RE: Proposed mixed use residential and retail development at 80-88 Regent Street, Redfern (SSD 7080) – Revised Response to Submissions (RTS)

Attachment A: Review of Response to Council Submission

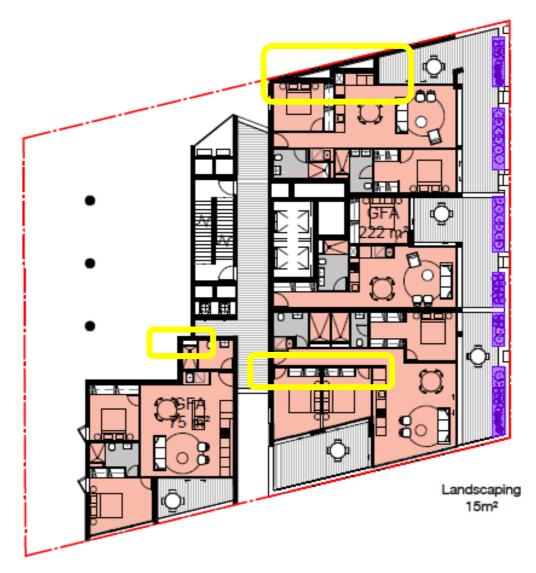
- The drawings illustrate a slight misalignment of the subject site and adjacent 68 70 Regent Street along the William Lane boundary which maintains an 800mm setback from the Lane.
- The doors along William Lane and Regent Street open outwards, encroaching onto the footpath. All doors must be designed to set-in from the footpath when open.
